IN REPLY REFER TO:
NCPC File No. Z.C. 08-02
OCT 07 2008

CASE NO. 08-02
EXHIBIT NO. 26

**MAP AMENDMENT FROM SP-2 TO C-4
HAY ADAMS HOTEL**

Delegated Action of the Executive Director

SOUTH ELEVATION WITH GUARD RAIL (SET BACK 3'-6")

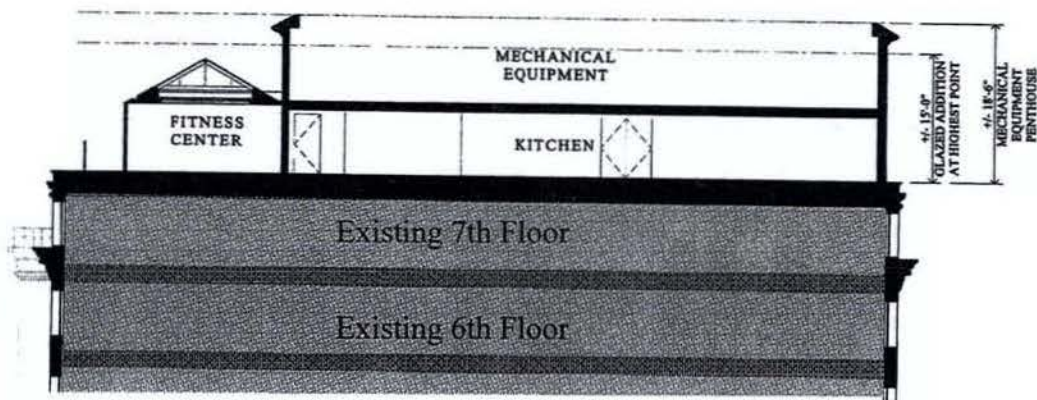
directly above the kitchen. The combined height of the kitchen and the penthouse is 18.5 feet above the existing seventh story roof. The proposed building height would increase from 82.6 feet to 101 feet to the top of the penthouse. The floor area ratio would increase from 7.35 to 7.99. This proposed height is below the allowed maximum height of 130 feet as set forth by the Height of Buildings Act of 1910, as amended.

As this building is directly across the street from the White House, both the United States Secret Service and the White House Office of Administration were informed of this proposal. Both agencies found the proposed text amendment and the additional floor on the Hay Adams Hotel acceptable and they requested that they be updated periodically on building material choice to ensure low reflectivity from the proposed new glazing.
